Site Accessibility Evaluation

Public Health WIC Office

**2948 E Fountain Blvd
Colorado Springs, CO
80910**

***Inspection Date: 08/23/2019
Inspector: David Mejia***

Finding: 1

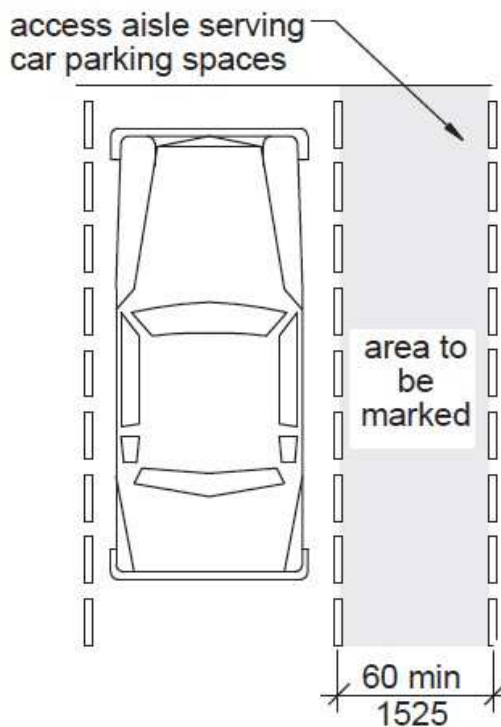
The access aisle is not a minimum 5 feet wide.

2010 ADAS Section 502.3.1

52.5 inches in width

Re-stripe access aisle and ensure a 60 inch minimum measured to the centerline of the paint stripe.

Finding: 2

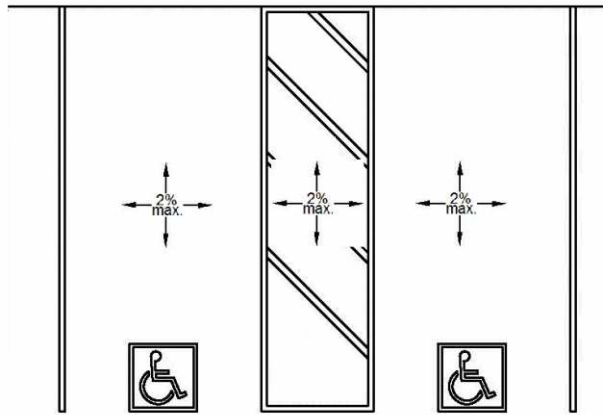
The running slope (long dimension) of the accessible parking stall exceeds 2%.

2010 ADAS Section 502.4

Van parking stall at
2.18 - 3.14 % running
slope

Re-pave and re-stripe 2 parking stalls and 1 access aisle ensuring running slope does NOT exceed 2% (1:48).

Finding: 3

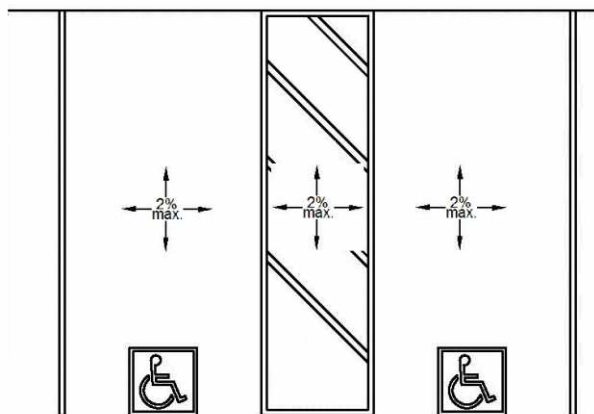
The running slope (long dimension) of the access isle exceeds 2%.

2010 ADAS Section 502.4

Running slope of
access aisle between
2.14% and 4.54%

Re-pave and re-stripe 2 parking stalls and 1 access aisle ensuring running slope does NOT exceed 2% (1:48).

Finding: 4

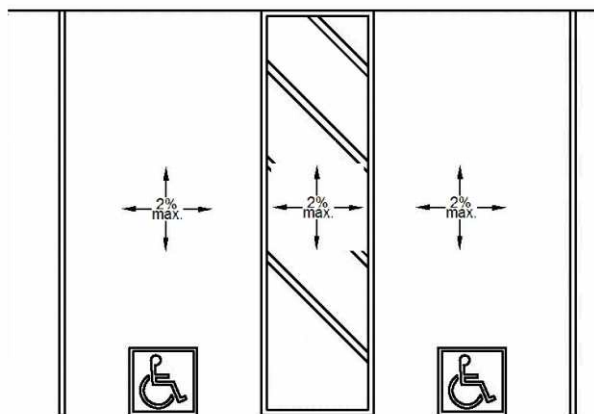
The running slope (long dimension) of the accessible parking stall exceeds 2%.

2010 ADAS Section 502.4

Accessible parking
stall running slope
between 3.14% - 4.00%

Re-pave and re-stripe 2 parking stalls and 1 access aisle ensuring running slope does NOT exceed 2% (1:48).

Finding: 5

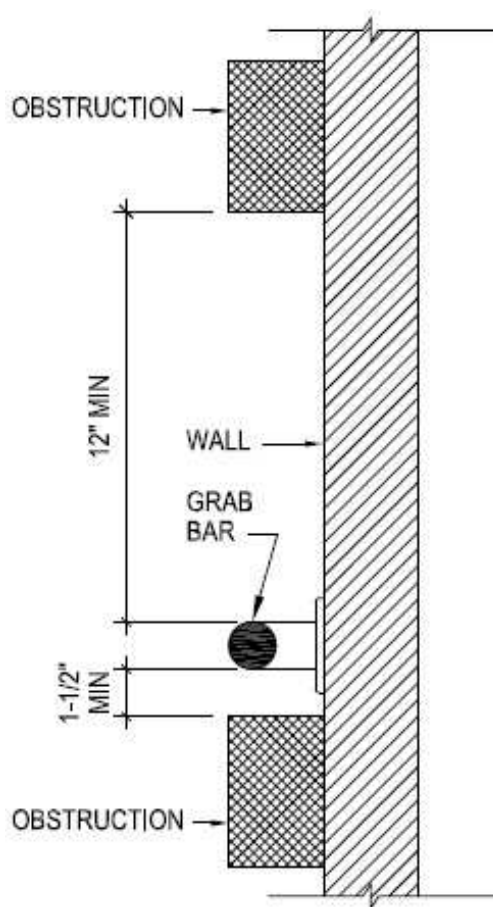
The toilet seat cover dispenser is mounted too close to the top of the grab bar, minimizing the gripping surface.

2010 ADAS Section 609.3

8.5 inches above rear
grab bar

Relocate seat cover dispenser to have operable part between 15 inches minimum and 48 inches maximum above floor. May require relocation below rear or side grab bar at 1.5 inches minimum clearance below grab bar to meet compliance.

Finding: 7

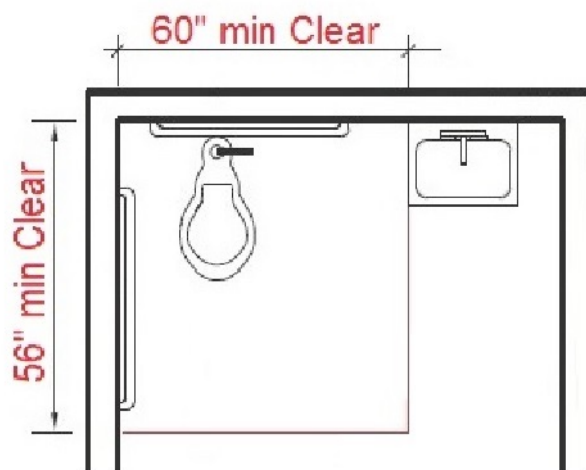
The lavatory projects into the clear floor space required for the toilet.

2010 ADAS Section 604.3.2

Lavatory projects into the required clear floor space of the toilet

Pre-existing condition. In future renovation/remodel, ensure water closet minimum required clear floor space of 60 inches in width x 59 inches in depth is not obstructed by lavatory or other fixtures.

Finding: 8

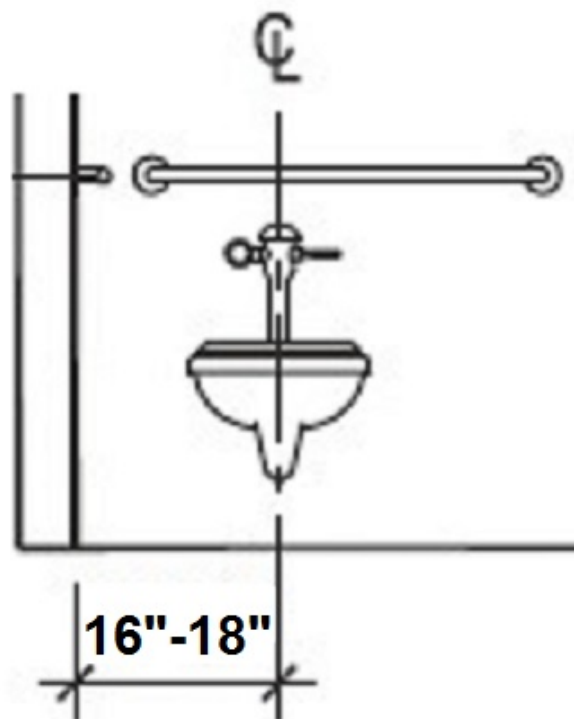
The toilet is not located within the range allowed from the side wall or partition.

2010 ADAS Section 604.2

19 inches from the side wall

Adjust toilet to measure between 16 inches minimum and 18 inches maximum from side wall.

Finding: 9

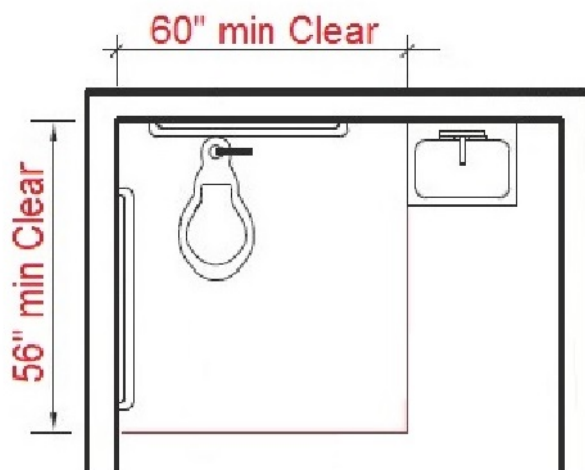
The clear floor space around the toilet is obstructed by the baby changing station.

2010 ADAS Section 604.3.2

Baby changing station
protrudes 4 inches
into required clear
floor space of toilet

Reposition baby changing station 4 inches minimum away from the required clear floor space of the toilet.

Finding: 10

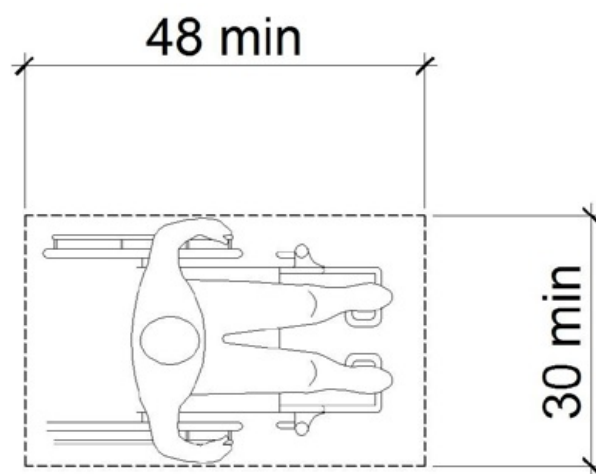
The lavatory's clear floor space is obstructed by the hand dryer.

2010 ADAS Section 606.2

Hand dryer projects
into lavatory's clear
floor space

Remove hand dryer due to protruding into the required clear floor space of the lavatory. Also, a paper towel dispenser already exists.

Finding: 11

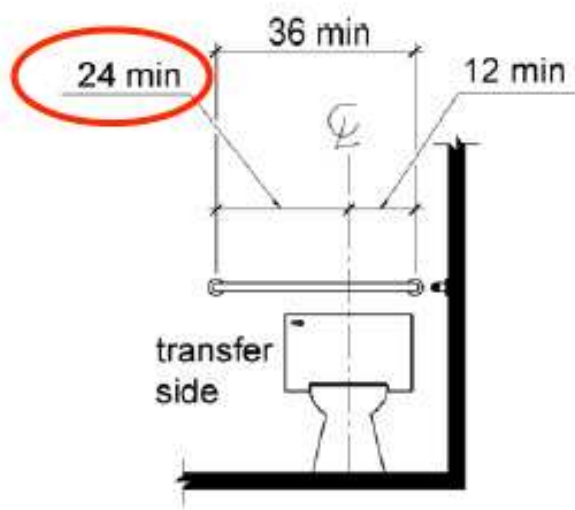
The rear grab bar does not extend adequately past the toilet on the wide side.

2010 ADAS Section 604.5.2

19 inches from center
of toilet

Re-position rear grab bar to extend 12 inches minimum on wall side and 24 inches minimum on the transfer side measured from the centerline of the toilet.

Finding: 12

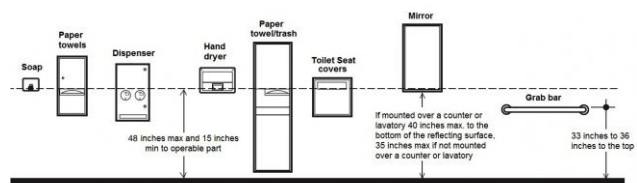
The paper towel dispenser's operation mechanism is too high off the floor.

2010 ADAS Section 308.2.1

Paper towel dispenser
protrudes 9.5 inches
into circulation path

Remove paper towel dispenser as it protrudes more than 4 inches from wall and could potentially be a safety hazard. Also, there is an electric hand dryer installed near the lavatory.

Finding: 13

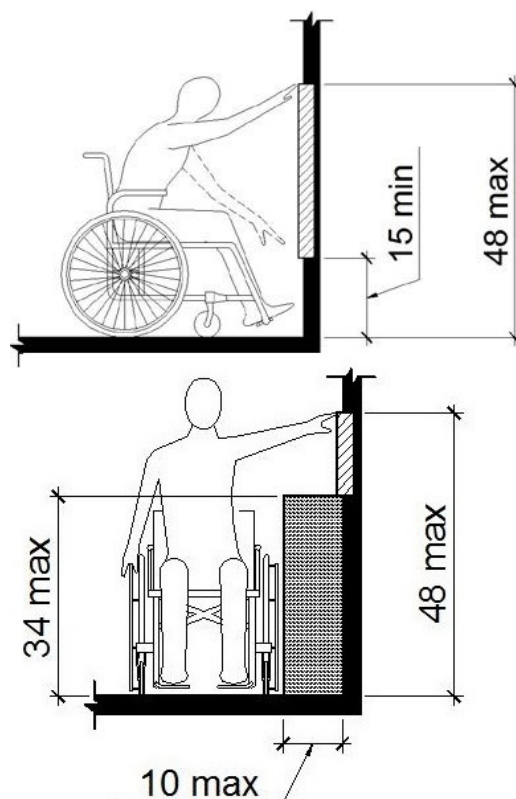
The coat hook is installed greater than 48 inches above the finished floor.

2010 ADAS Section 308.2.1

Coat hook at 66 inches
above finish floor

Lower coat hook 20 inches minimum or install another coat hook not to exceed a maximum height of 48 inches above finished floor.

Finding: 14

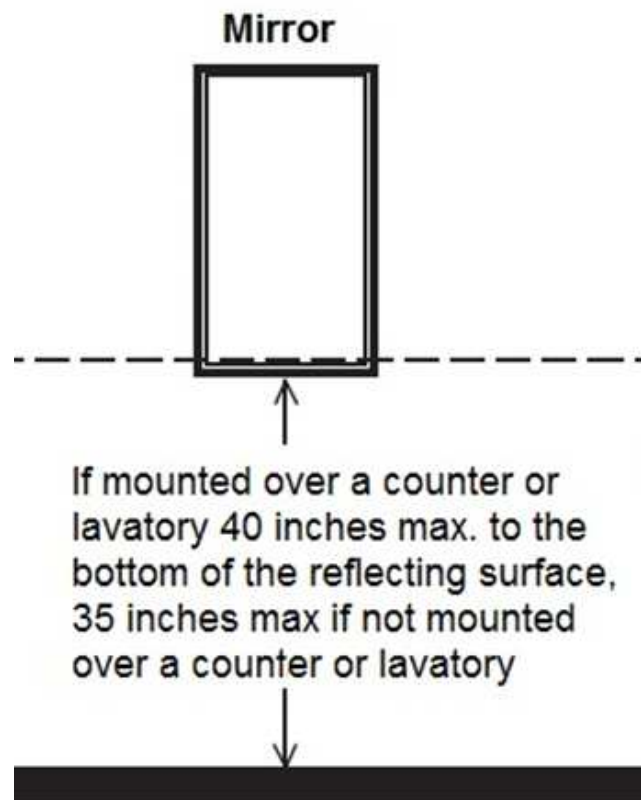
The mirror is mounted too high.

2010 ADAS Section 603.3

Mirror height at 40.25
inches above finished
floor

Lower mirror to a maximum of 40 inches above finished floor measured to the bottom edge of the reflective surface. Recommend lowering mirror 1 inch.

Finding: 15

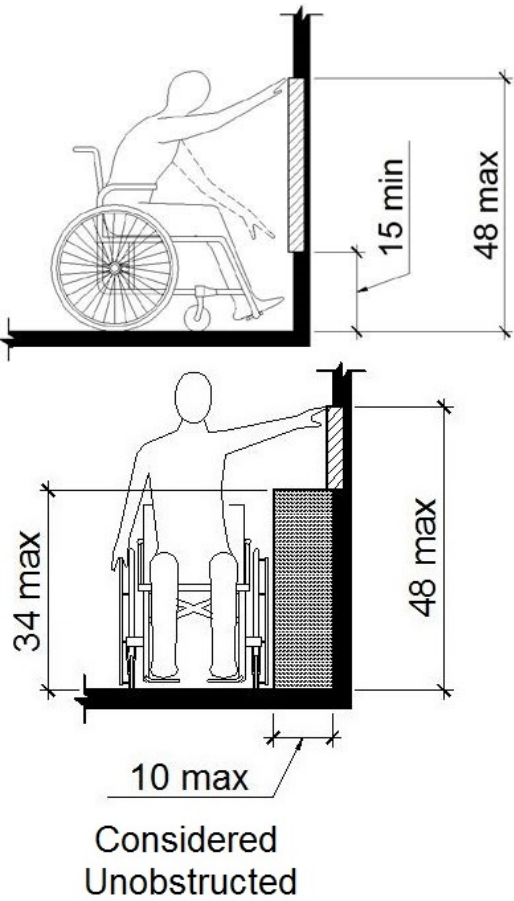
The informational shelf is positioned too high for either a side or front approach.

2010 ADAS Section: 308.2.1, 308.3.1

Top shelf brochures at
68 inches above
finished floor

Lower informational shelf to provide access to brochures or reconfigure brochures to ensure a reach range of no more than 48 inches above finished floor.

Finding: 16

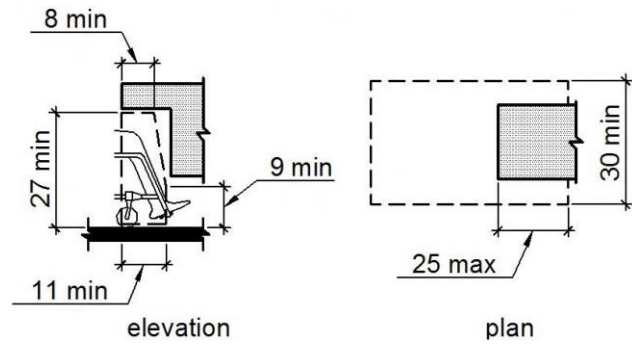
The knee clearance not compliant.

2010 ADAS Section 306.3.3

No knee or toe
clearance provided
underneath desk

Move computer to the side of desk to provide knee clearance underneath desk.

Finding: 17

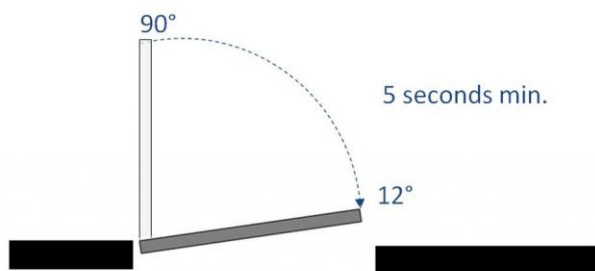
The door is equipped with a door closer and returns to a closed position too quickly.

2010 ADAS Section 404.2.8.1

3.2 seconds to closed position

Adjust door closer to allow a minimum of 5 seconds before returning to a position of 12 degrees from the latch/locking mechanism.
